TENANT IMPROVEMENT PLAN CHECK COMMENTS

PLAN CHECK NO:	10174450	
PROJECT ADDRESS:	2800 N Main St Unit# 1040	
PLAN CHECK ENGINEER:	Mazarji, Zac	TEL: 714 647-5831
		FAX: 714 647-5897
TYPE OF CONSTRUCTION:	II B, SPK	
OCCUPANCY CLASSIFICATION(S):	A-2	
PLAN CHECK DATES:		REMARKS/RECHECK ITEMS:
APPLICATION	2/23/2012	
INITIAL REVIEW	2/26/2012	
EXPIRATION	8/21/2012	
RECHECKS:	1.	PROJECT APPLICANT CONTACT PERSON: Nick Adachi
	2.	
	3.	
VALUATION:	\$30,000.00	TEL: (949)455-1144
		FAX: (949)472-8066
FLOOD ZONE:	X-0602320163J	EMAIL: naa@nickadachi.com

GENKI SUSHI T.I.

GENKI SUSHI EXTERIOR & PATIO IMPROVEMENT

GLASS DOOR INFORMATION 4

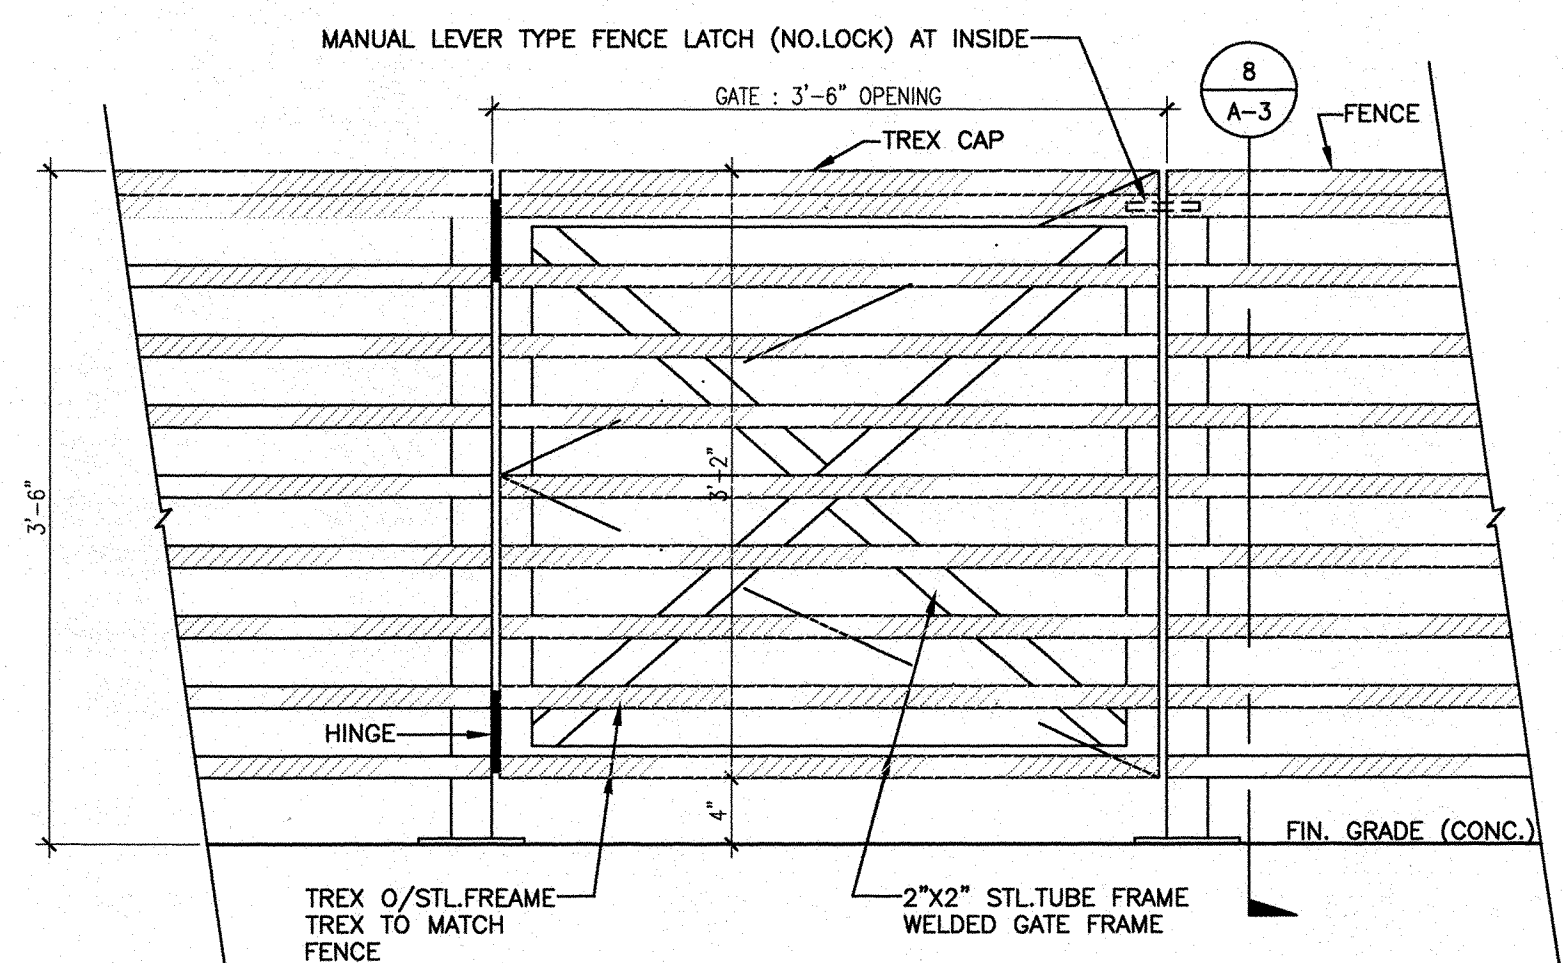
- By the Fire Department
16. CBC Section 1133B.2.5, Note on the drawings: "Maximum effort to operate doors shall not exceed 5 pounds for exterior Gate/doors and interior doors, such pull or push effort being applied at right angles to hinged doors and at the center place of sliding or folding doors." **4/A-2 GLASS DR. INFO. NOTES 1-24**

GATE DETAIL SCALE: 1" = 1'-0" 5

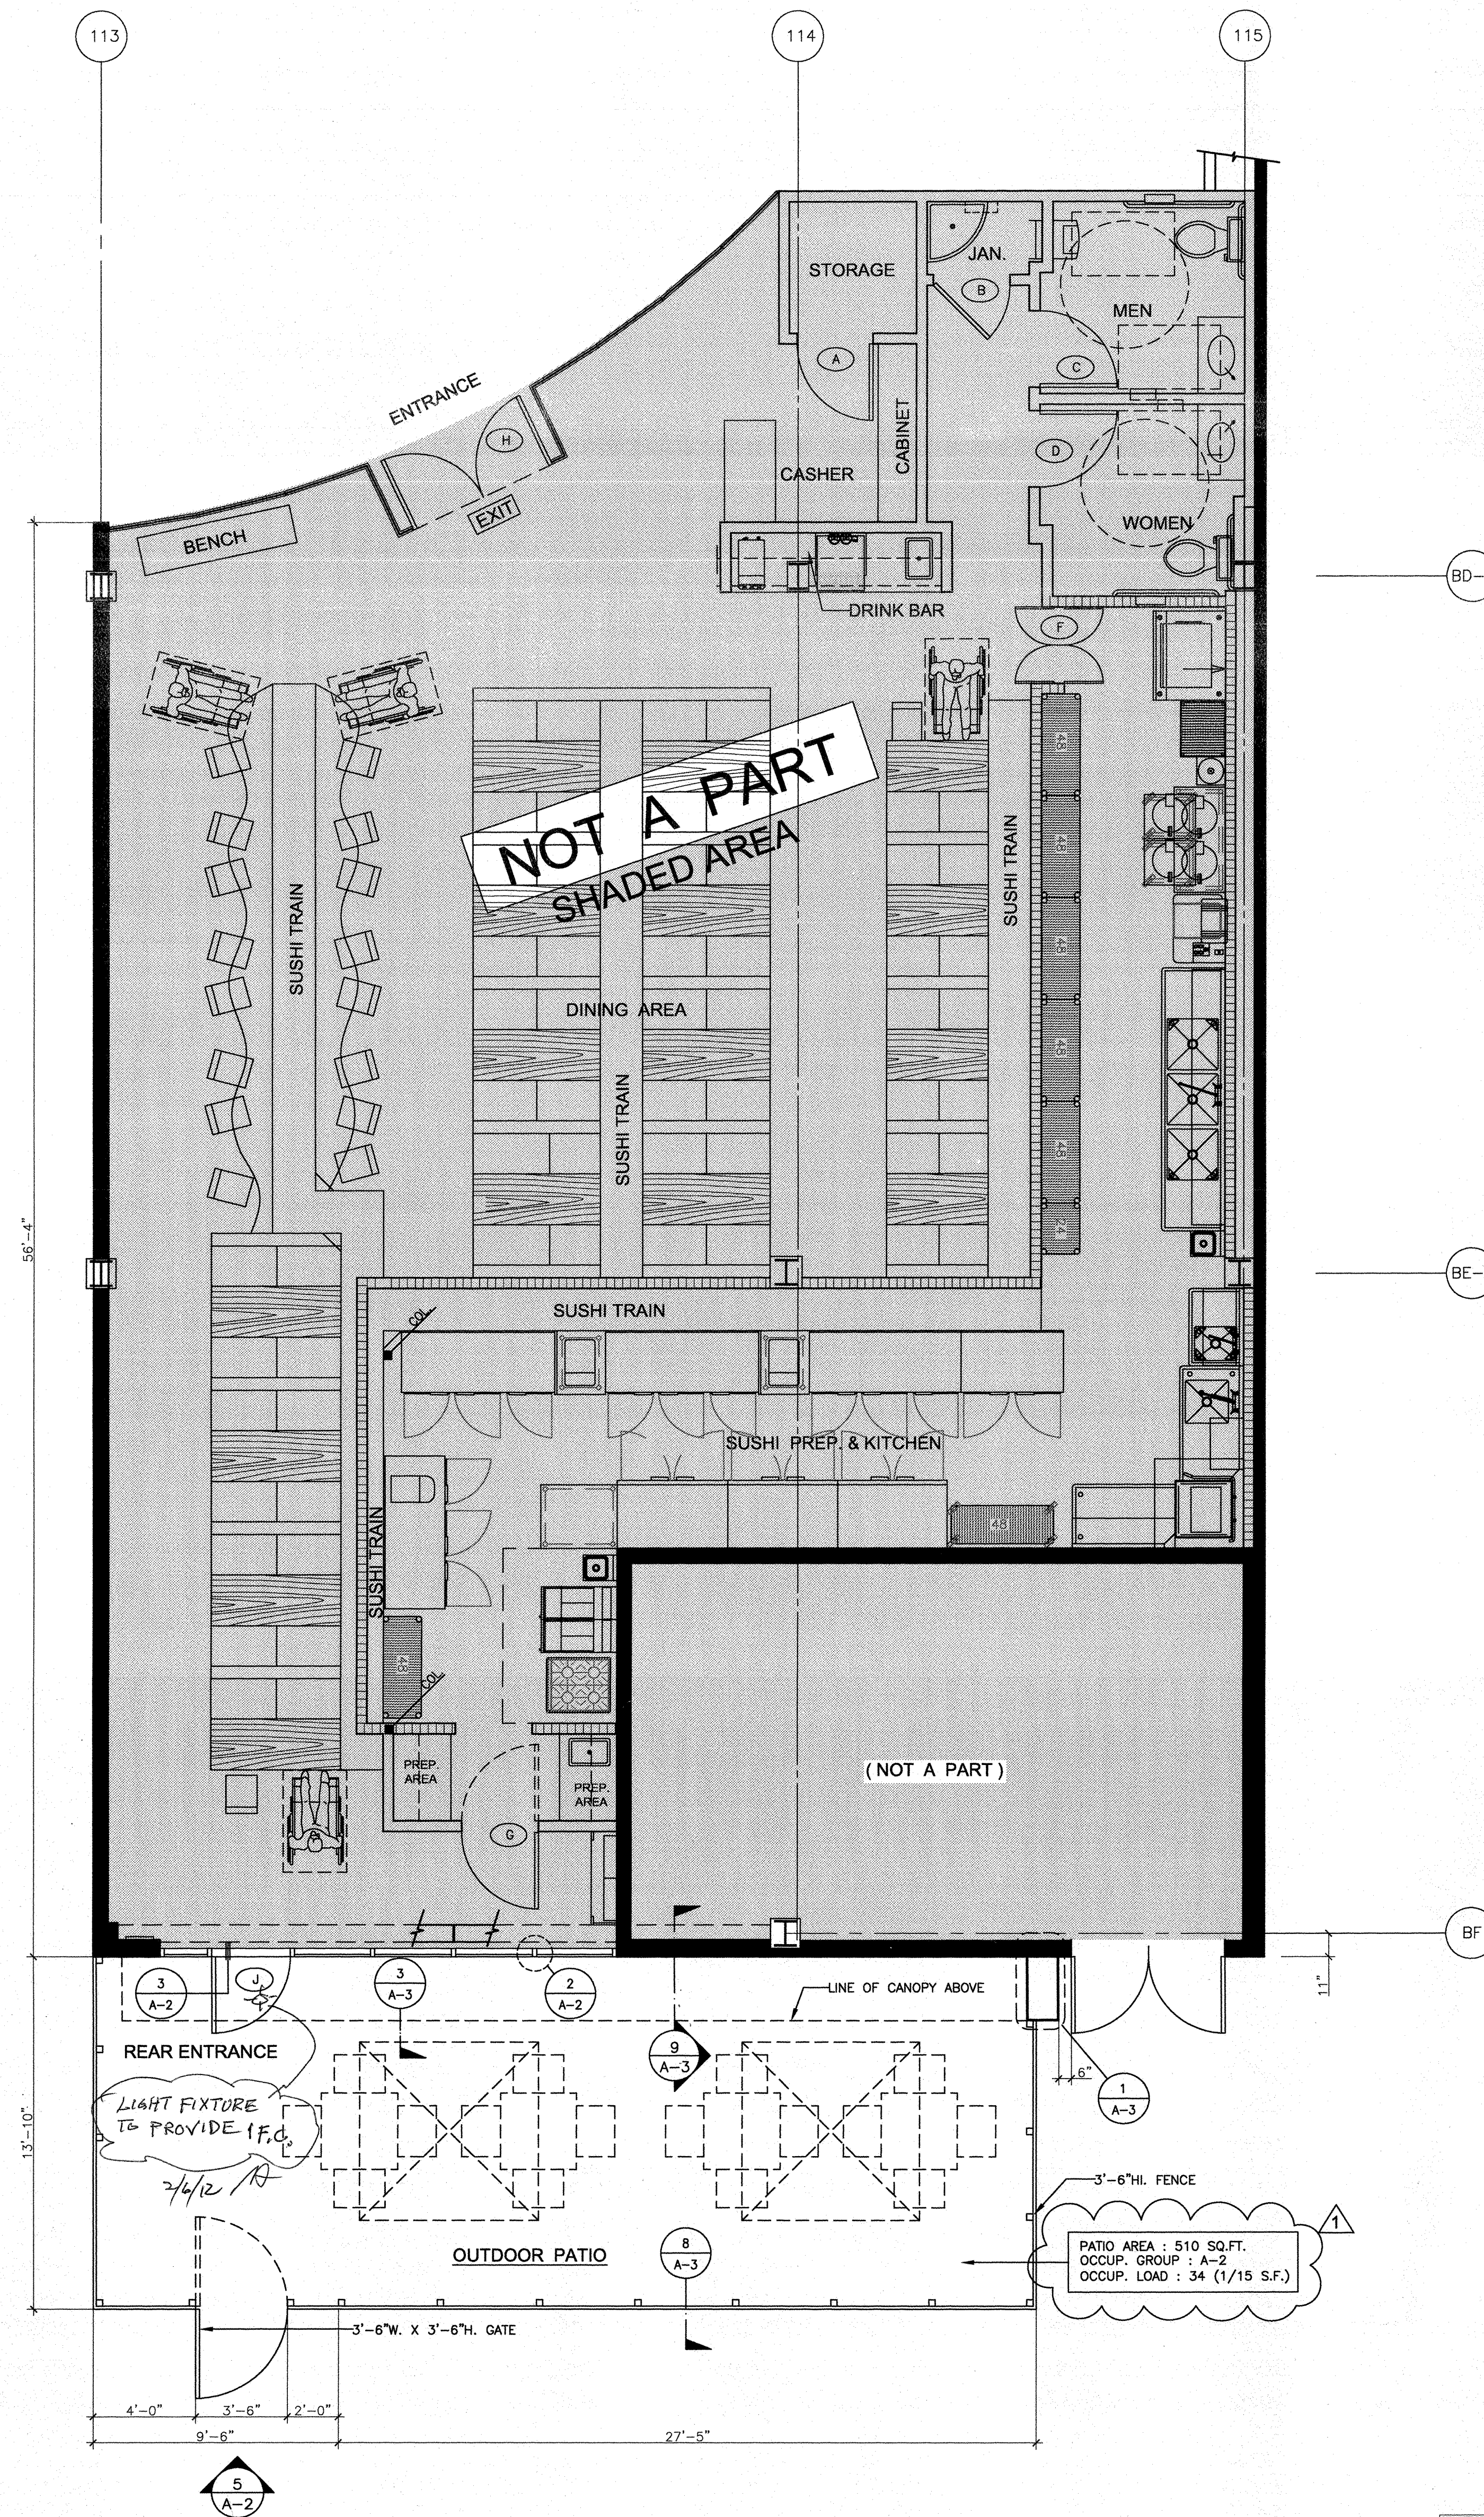
14. Provide on the drawings a complete Gate/ door schedule, showing: **ADDED GATE DET. 5/A-2**
 - Hardware complying with exiting and disabled accessibility requirements (CBC Sections 1008.1.8 and 1133B.2.5)

20. Gate/ doors, which are part of a required means of egress, shall conform to the following:

- They must remain secured in the full open position during the period of occupancy by the general public.
- Doors / Gates shall not be brought to the closed position when there are more than 10 persons occupying spaces served by a single exit or 50 persons occupying spaces served by more than one exit.
- The doors / Gate shall be openable from within without the use of any special knowledge or effort when the space is occupied.

NOTES 1~3
5/A-2

PATIO FENCE SCALE : 1 1/2" = 1'-0" 8

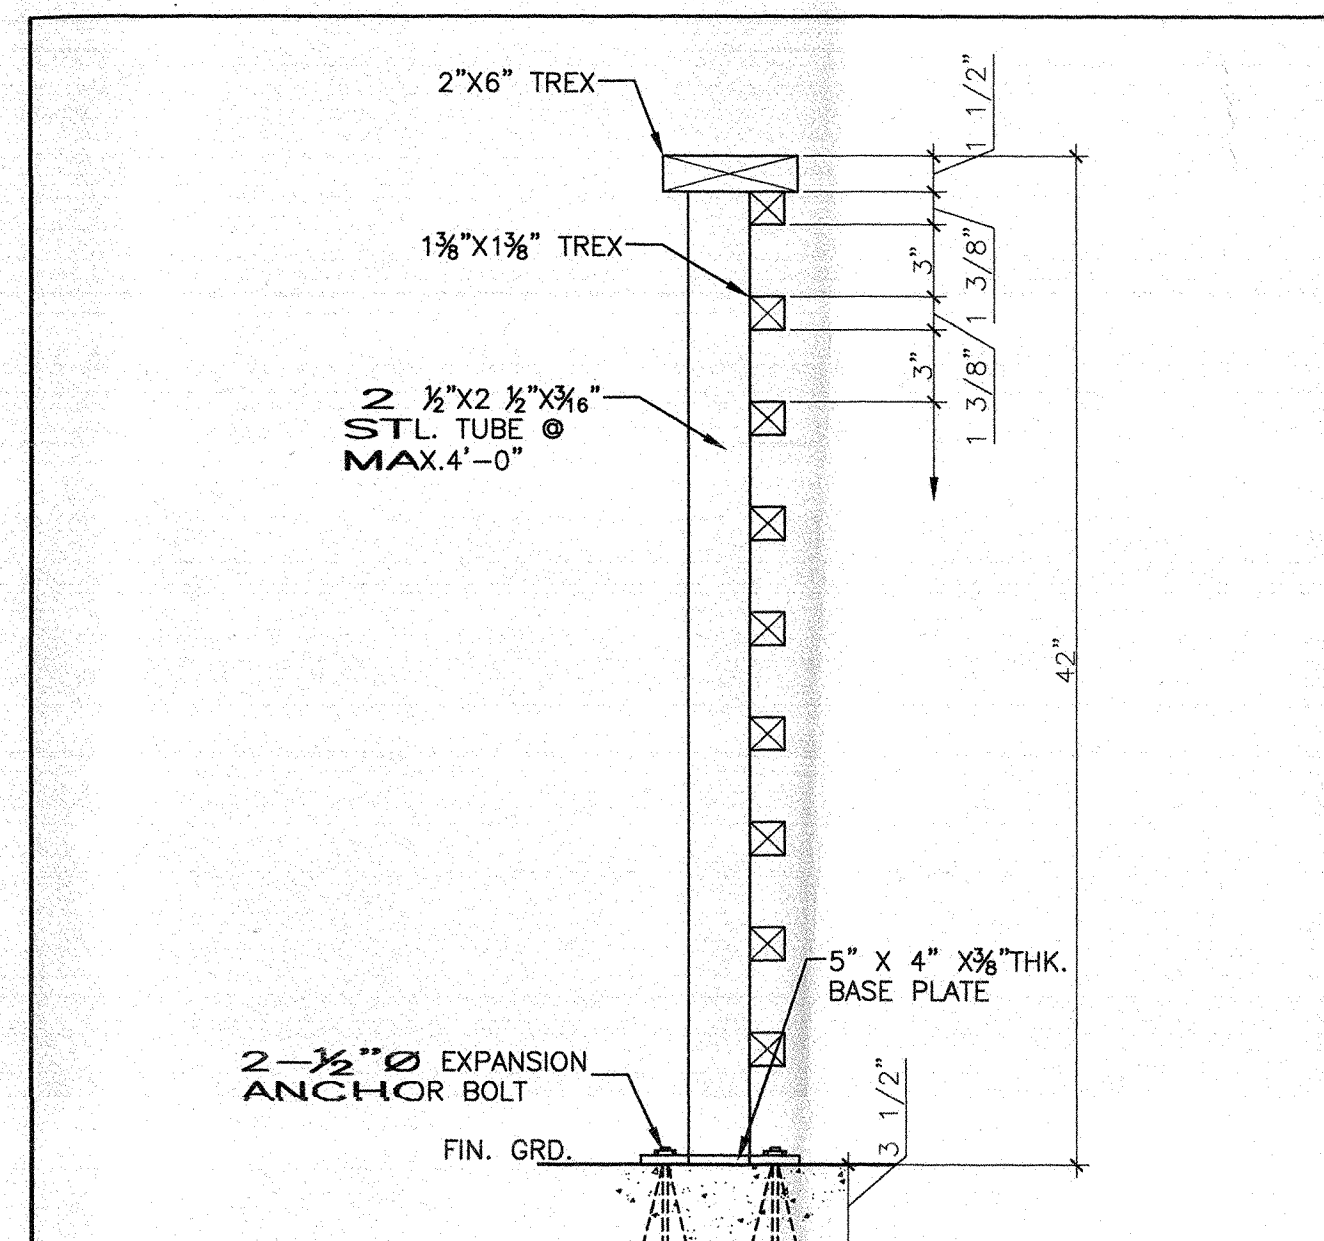
11. Reference Detail #8 of sheet A-3 Provide specifications for TREX. Type II-B requires Non-combustible construction. **N/A PER PHONE CONVERSATION**
12. Please note on the drawings that all expansion bolts require special inspection. **SHT. A-1.0 STRUC. NOTES**

PATIO CANOPY SCALE : 1 1/2" = 1'-0" 9

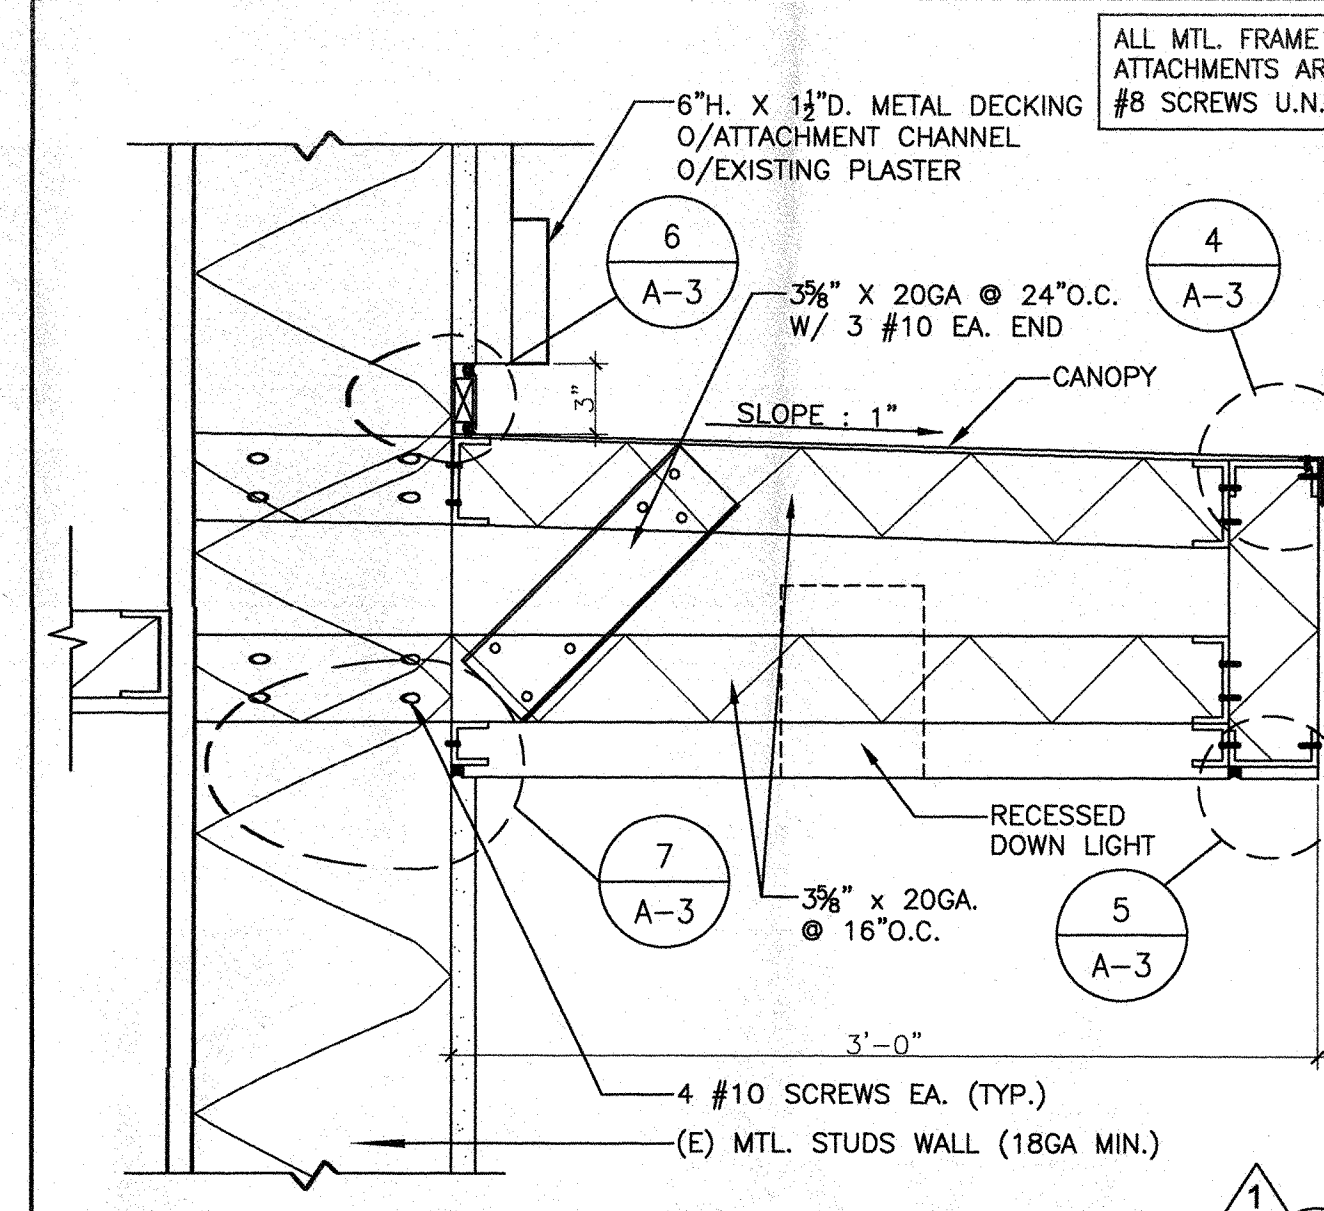
13. Provide typical section view detail of all new partitions and ceilings showing:
 - Note gauge and ICC Research Report number and installation/construction requirements for metal framing members. **#4782** **SHT. A-1.0 STRUC. NOTE** **& CANOPY DET. 1-23 & 9/A-3 FOR GAGES & CONNECTION**
